Addendum 47 – UN Regulation No. 48

Revision 12 - Amendment 13

Supplement 16 to the 06 series of amendments – Date of entry into force: 4 January 2023

Uniform provisions concerning the approval of vehicles with regard to the installation of lighting and light-signalling devices

Annex 1, item 9.22., amend to read:

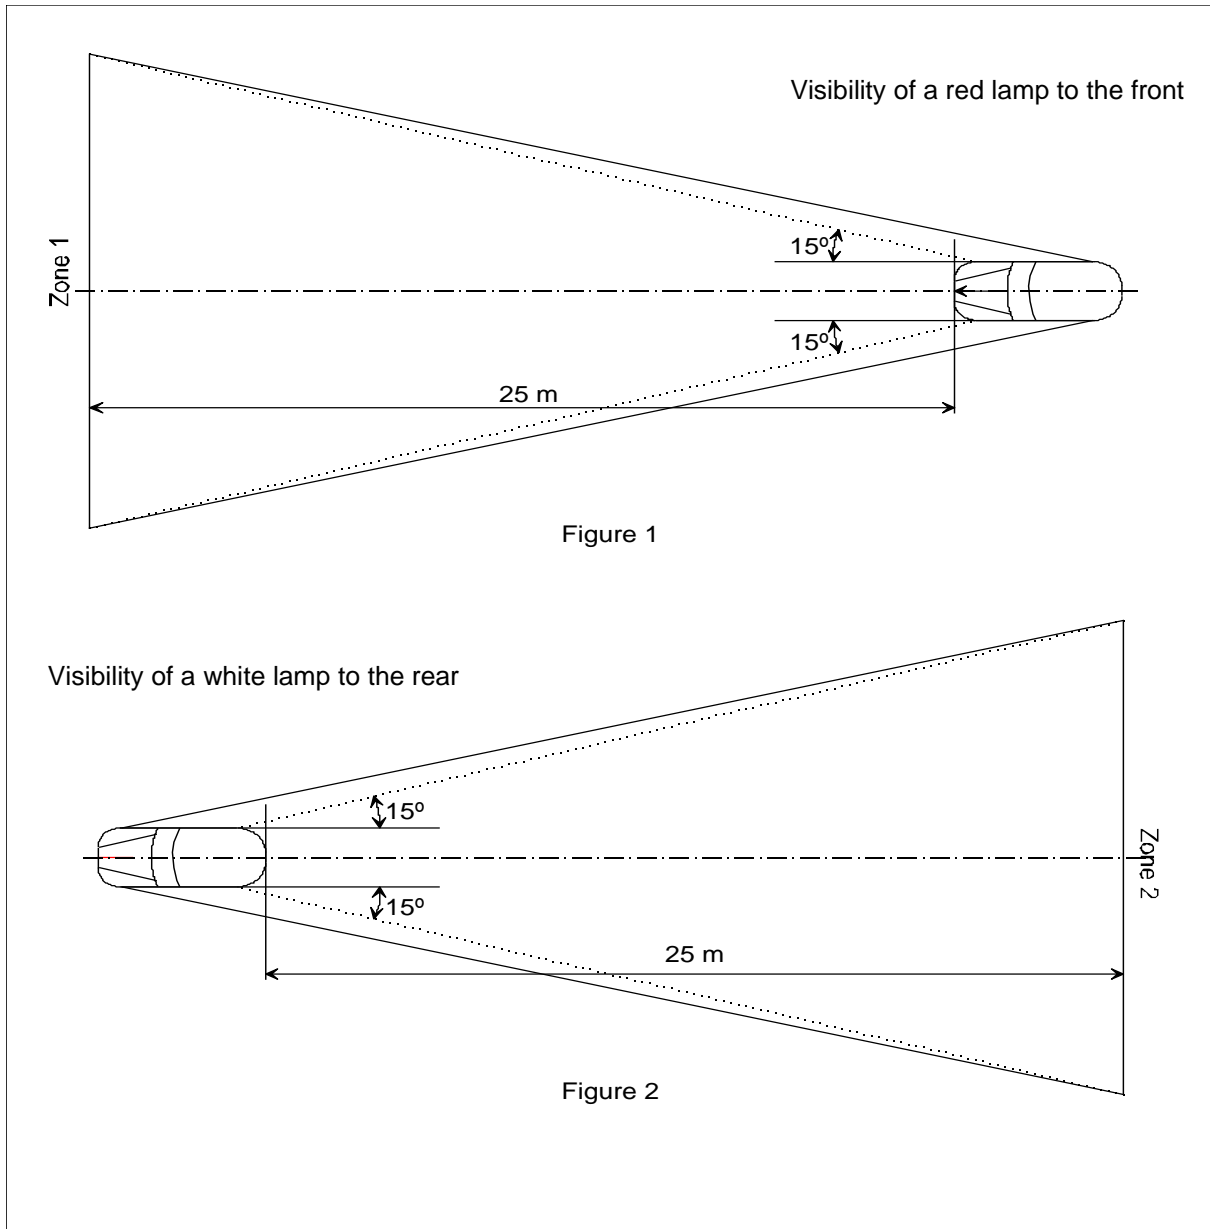
"9.22.	Adaptive front lighting system (AFS):	yes/no ²
9.22.1.	Main-beam ADB	yes/no ²
9.22.1.1.	Main-beam ADB + Driver Assistance Projection	yes/no ² "

"Annex 4

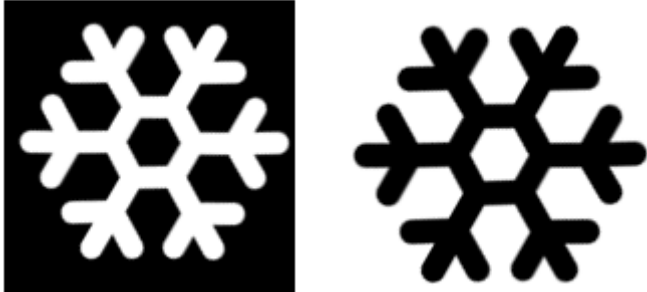
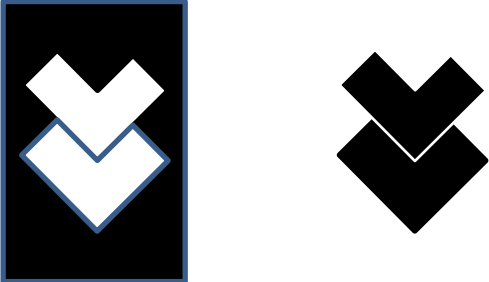
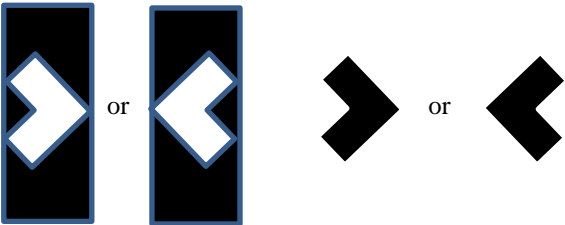
In their respective planes, the zones 1 and 2 explored by the eye of the observer are bounded:

- In height, by two horizontal planes 1 m and 2.2 m respectively above the ground;
- In width, by two vertical planes which, forming to the front and to the rear respectively an angle of 15° outwards from the vehicle's median longitudinal plane, pass through the point or points of contact of vertical planes parallel to the vehicle's median longitudinal plane delimiting the vehicle's overall width; if there are several points of contact, the foremost shall correspond to the forward plane and the rearmost to the rearward plane."
